Freightliner
Service Bulletin

Description of Revisions: *This bulletin replaces the version dated May 2011. A step is added for installing a new PNDB.*

The 3-fuse MEGA Fuse Junction Block (MFJB) on most Century Class, Cascadia, and Columbia vehicles can be replaced with a "de-populated" service version of the Power Net Distribution Box (PNDB). See [Fig. 1](#). Use the instructions in this bulletin to make this modification.

Fig. 3, Labeled Cables on the MFJB

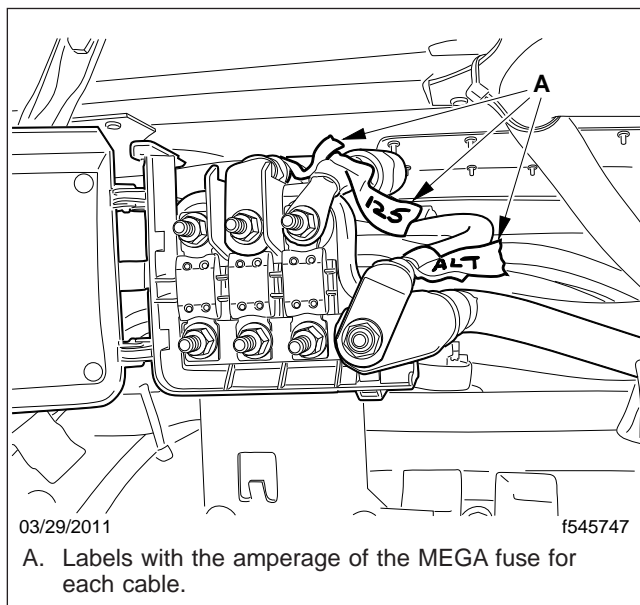
1. Chock the tires and disconnect the batteries at the negative terminals. If the vehicle has an auxiliary battery system, disconnect these batteries.
2. If the vehicle is equipped with side fairings, remove the forward driver side fairing to access the MFJB. See [Fig. 2](#).
3. Attach labels on each MEGA fuse cable noting the amperage and circuit function. See [Fig. 3](#).
4. Remove the MEGA fuse junction block.

Fig. 4, PNDB Installed with New Fuses

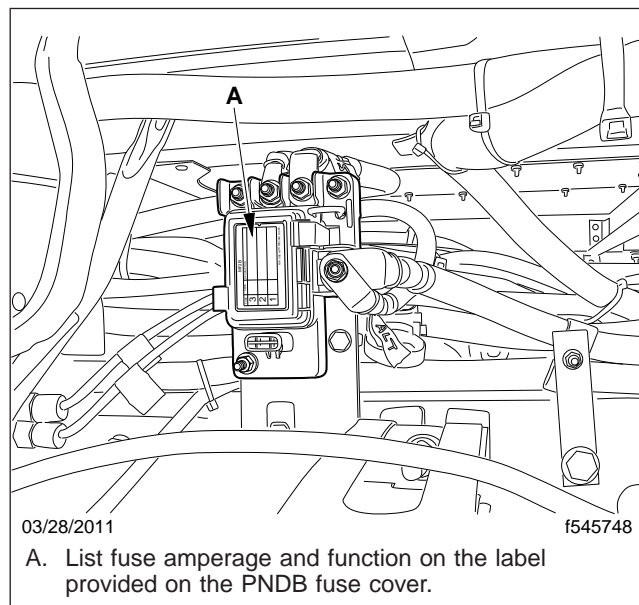
5. Install the PNDB-Adapter bracket assembly (p/n BSY 880096001A). Use the same mounting holes that were used for the MFJB.
6. Note the fuse amperage and location on the fuse cover with a permanent marker. See [Fig. 4](#).
7. Position the PNDB on the mounting bracket, and attach the two mounting nuts.

8. Install the correct amperage MIDI fuses in the PNDB for each circuit. Secure the fuse cover in place. See [Table 1](#).
